Project Name: Forest View - HVAC

Project No.: 221125-260

This Addendum is issued to inform the bidders of modifications in the scope of work being bid for this project.

END OF ADDENDUM NO. [#2]

FIRST FLOOR POWER PLAN - UNIT 300
SCALE: 1/8" = 1'-0"

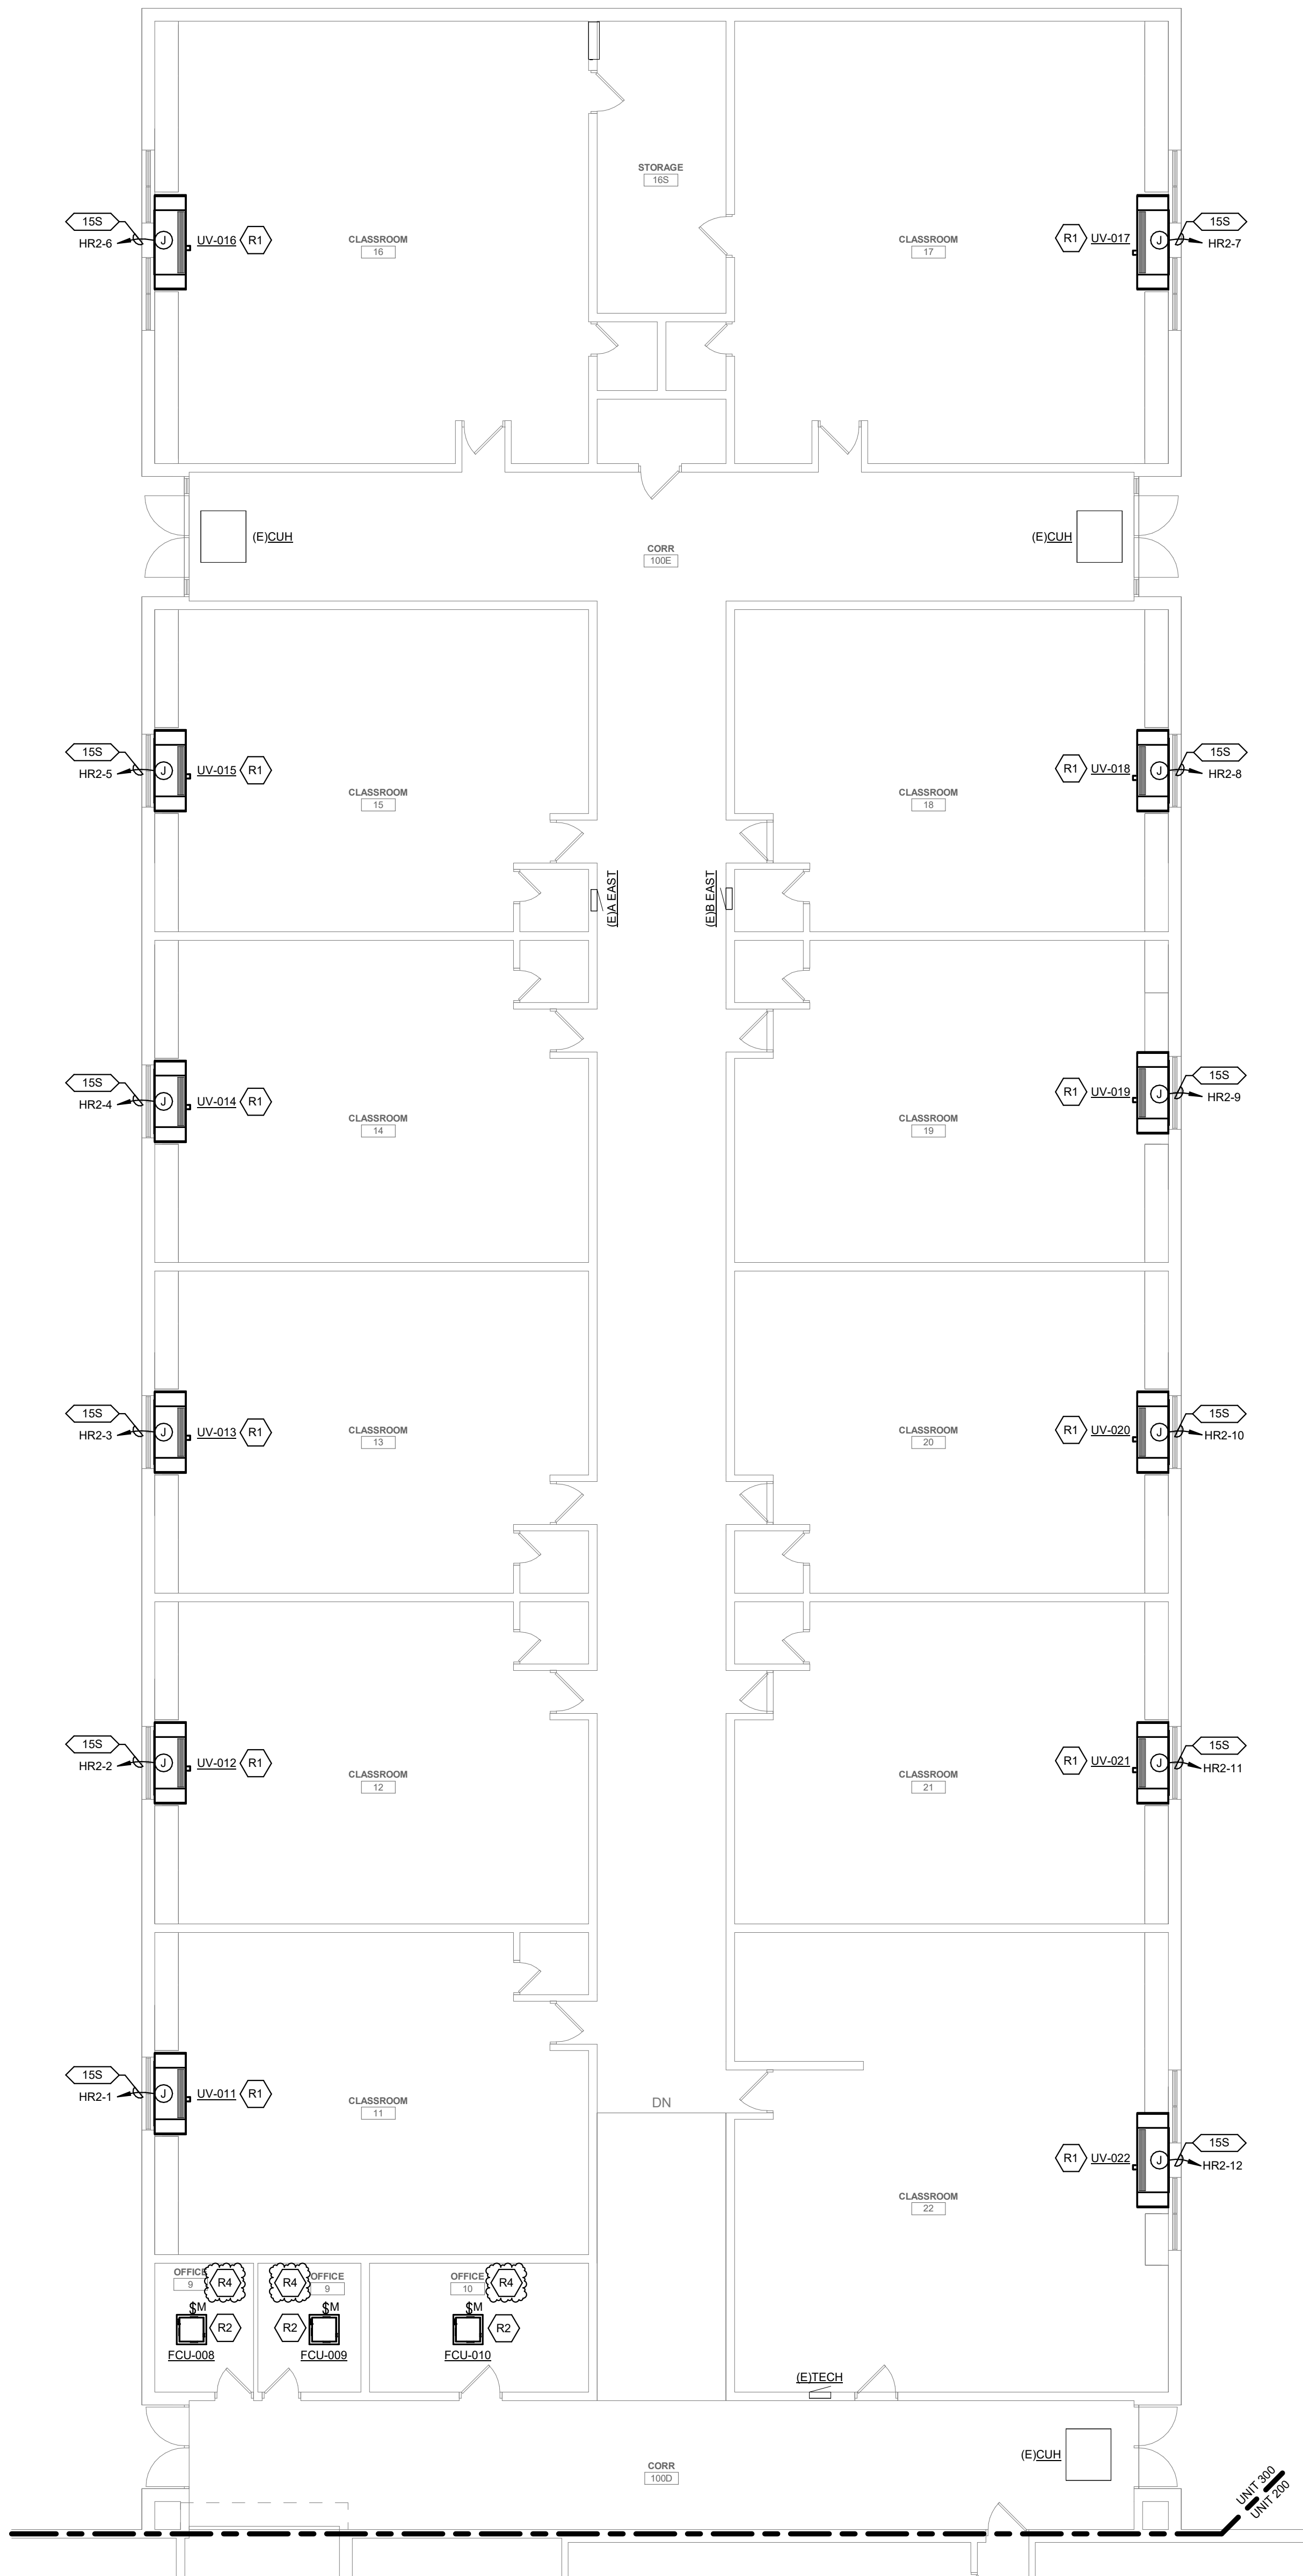
- Added keynote R4
- Added keynote R4 to office areas where indicated.
